PROPOSED TECHNICAL SPECIFICATION (TS) CHANGE

SEQUOYAH NUCLEAR PLANT UNITS 1 AND 2

DEPARTURE FROM NUCLEATE BOILING RATIO (DNBR) LIMITS BASES CHANGE

- 1) NUCLEAR PLANT(S): Sequoyah Units 1 and 2
- 2) SUBJECT (TITLE): Increased F Delta H from 1.55 to 1.62, Increased FQ From 2.32 to 2.4, With Mini RTDP
- 3) The written safety evaluation of the revised procedure, design change or modification required by 10CFR50.59(b) has been prepared to the extent required and is attached. If a safety evaluation is not required or is incomplete for any reason, explain on Page 2.

<p>SEQUOYAH FINAL SAFETY ANALYSIS REPORT UNITS 1 and 2</p>
<p>Partial Loss of Forced Reactor Coolant Flow Nuclear Power vs. Time</p>
<p>Figure 15.2.5-2c</p>

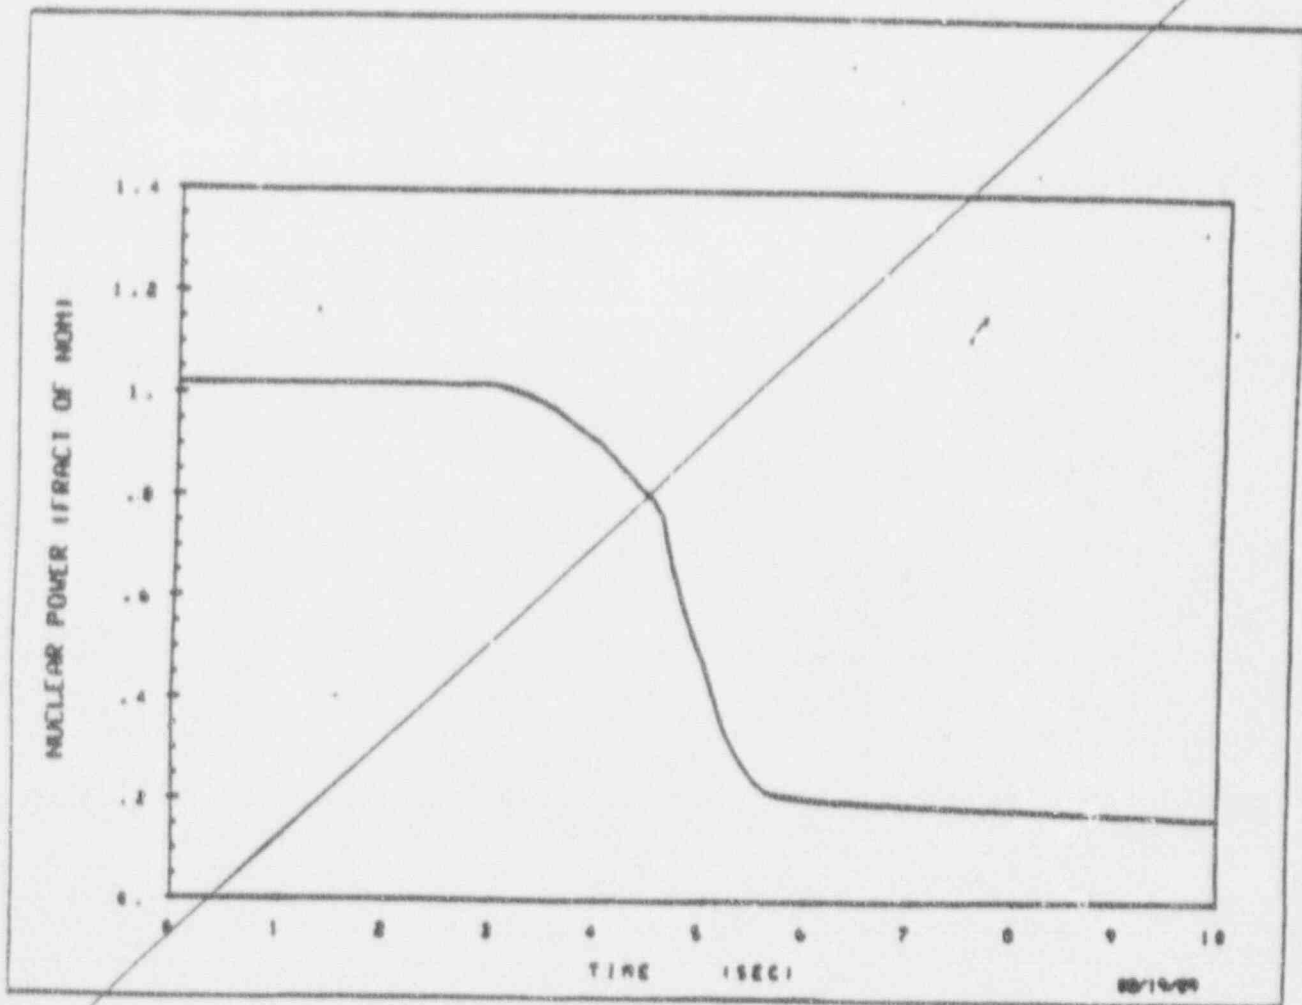
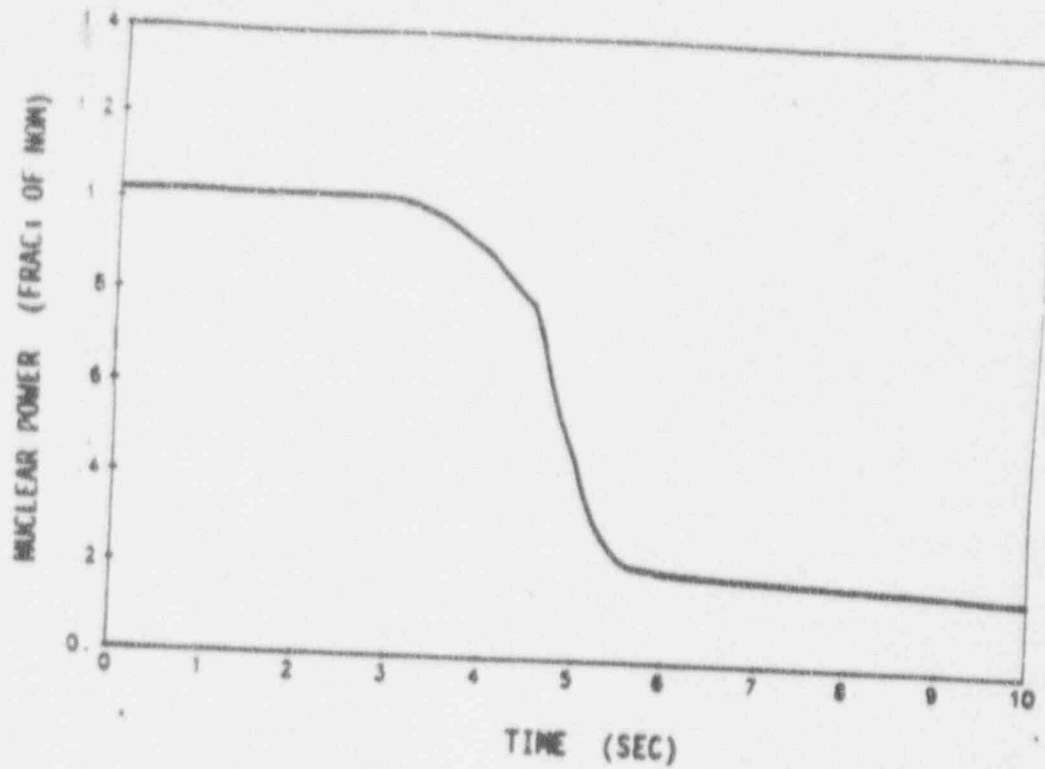
- 9.1.4 For the Partial Loss of Flow event the following changes were made: Text changes, Reference 3 update, Table 15.2-1 (sheet 2) revised, and Figures 15.2.5-1 through 15.2.5-3 were replaced.

REPLACE WITH THE FOLLOWING

SEQUOYAH FINAL SAFETY ANALYSIS REPORT UNITS 1 and 2
Rod Cluster Control Assembly Ejection Nuclear Power vs. Time (EOL, HFP)
Figure 15.4.6-1

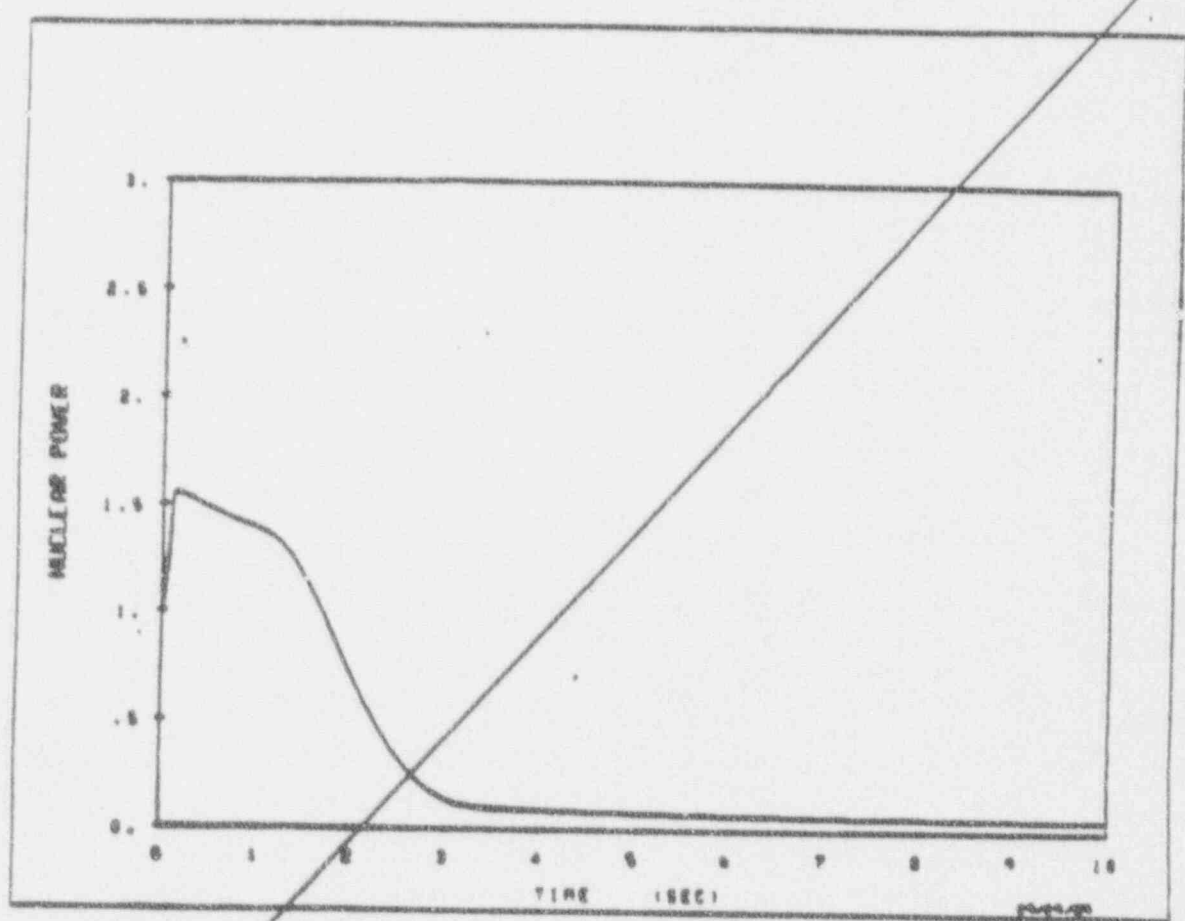
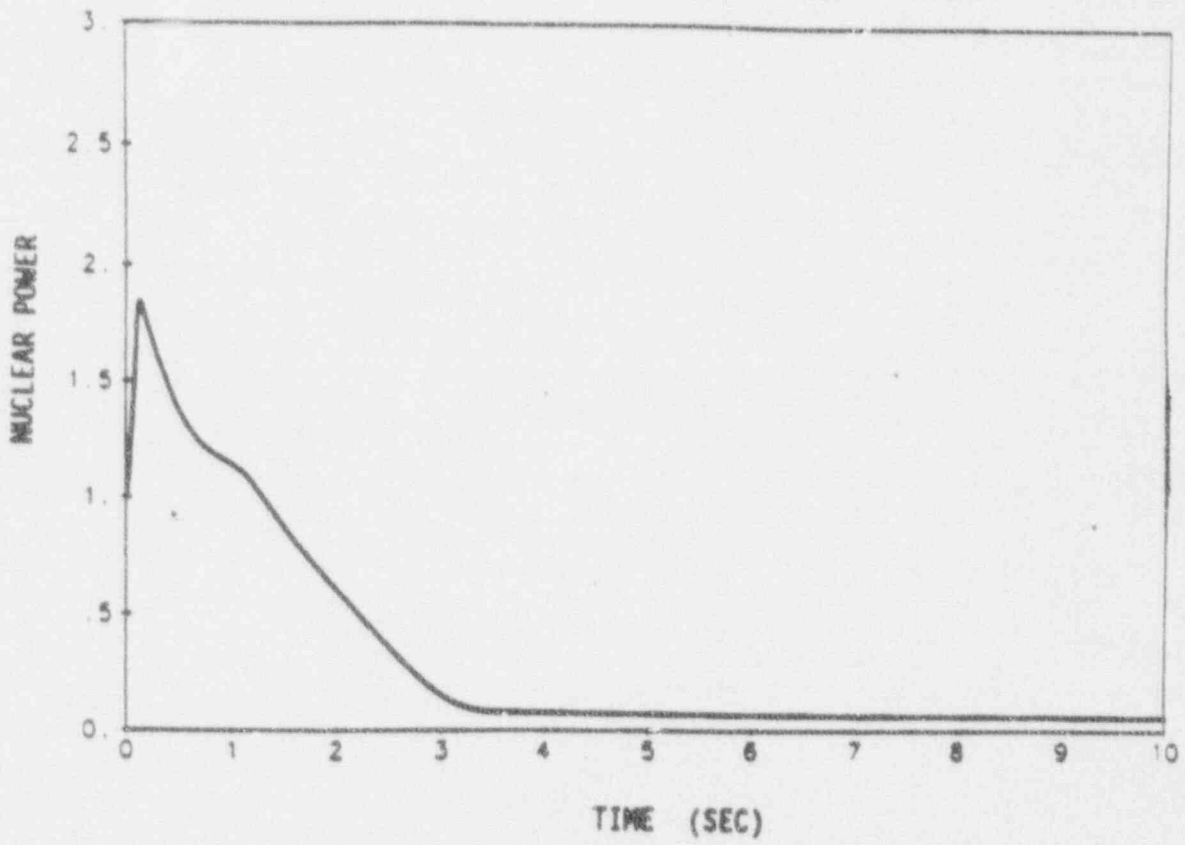
- 9.1.5 For the RCCA Ejection event the following changes were made: Text changes, References 25 and 29 updated, Tables 15.4.1-12 (sheet 3) and 15.4.6-1 were revised, and Figures 15.4.6-1 through 15.4.6-2 were replaced.

Replace with the following
